**TENNESSEE VALLEY AUTHORITY  
BROWNS FERRY NUCLEAR PLANT (BFN)  
UNIT 1**

**BROWNS FERRY NUCLEAR PLANT (BFN) - UNIT 1 - TECHNICAL  
SPECIFICATIONS (TS) CHANGE TS-431, SUPPLEMENT 1 -  
EXTENDED POWER UPRATE (EPU)**

**TVA EVALUATION OF THE PROPOSED CHANGE**

Figure 3.4.1-1  
THERMAL POWER VERSUS CORE FLOW STABILITY REGIONS

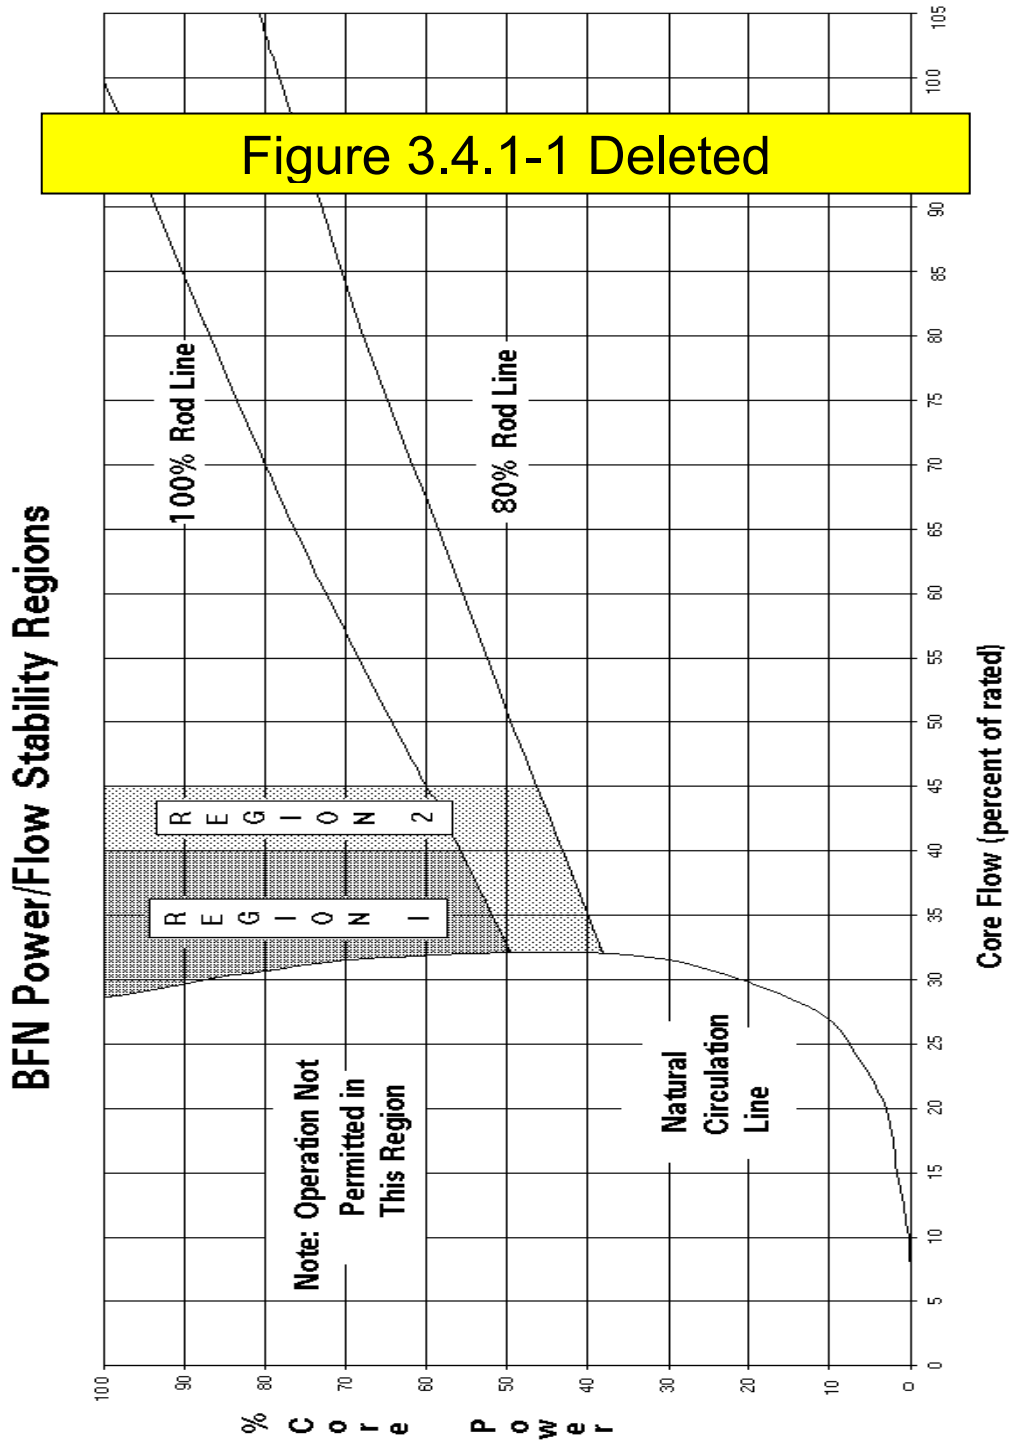
FIGURE 3.4.1-1 Deleted
